SHEARON HARRIS NUCLEAR POWER PLANT  
DOCKET NO. 50-400/LICENSE NO. NPF-63  
CHANGE TO EMERGENCY PLAN IMPLEMENTING PROCEDURE

CHANGE TO EMERGENCY PLAN IMPLEMENTING PROCEDURE

<u>PROCEDURE NUMBER</u>	<u>TITLE</u>	<u>EFFECTIVE DATE</u>
PEP-110 Revision 10	Emergency Classification and Protective Action Recommendations	08/22/02

TITLE: Emergency Classification and  
Protective Action Recommendations

**EAL FLOWPATH SIDE 1**

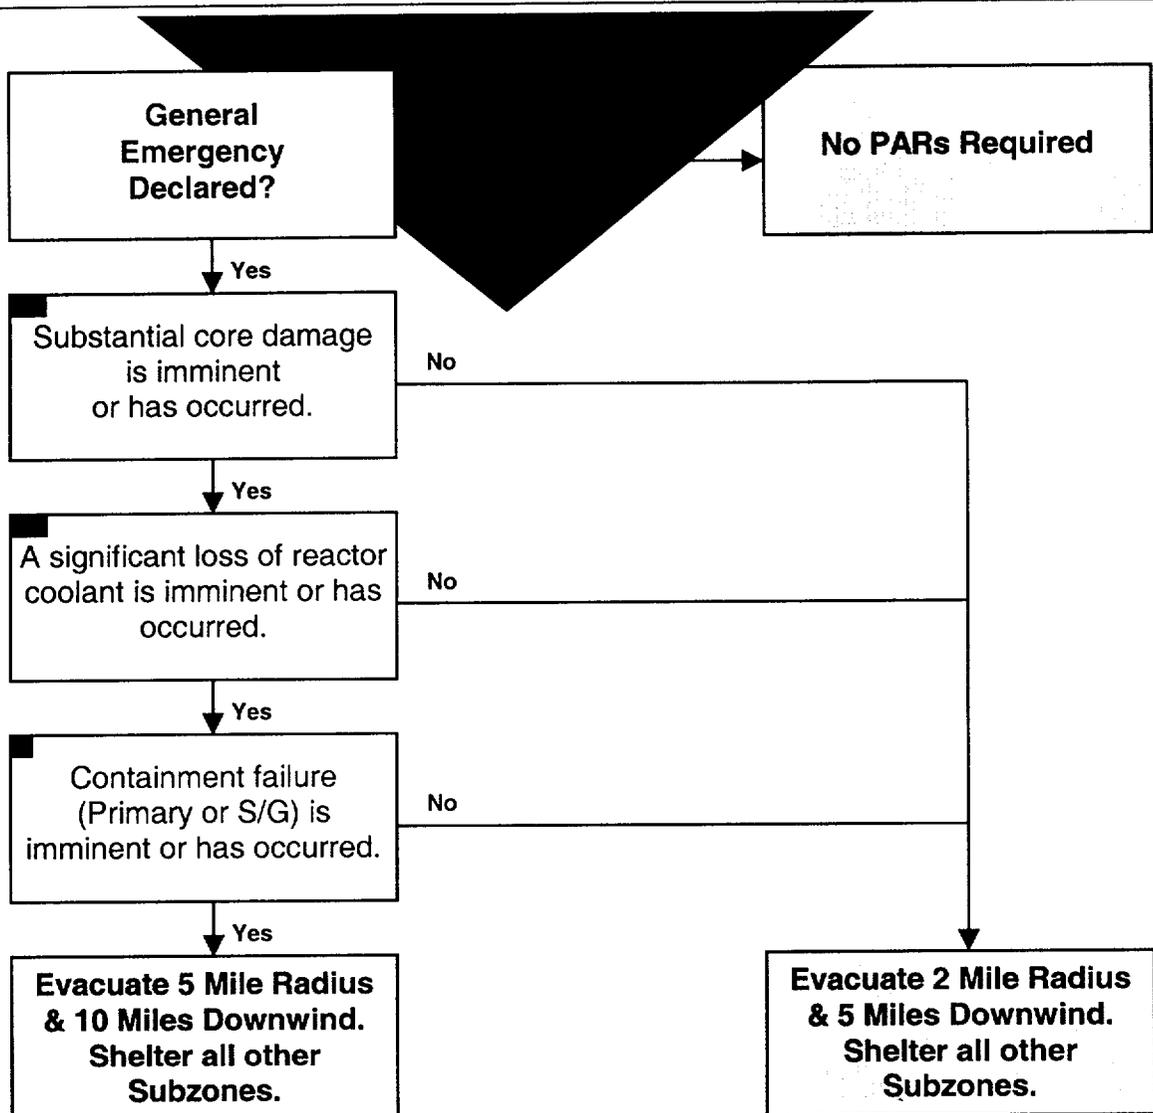
<b>Pg/Section</b>	<b>Changes</b>
Pg. 14 / Attachment 1	The Emergency Action Level (EAL) flow path Side 1 was updated to remove loss of Erfis from unusual event matrix
Pg. 15 / Attachment 2	The Emergency Action Level (EAL) flow path Side 2 was updated to remove loss of Erfis from unusual event matrix
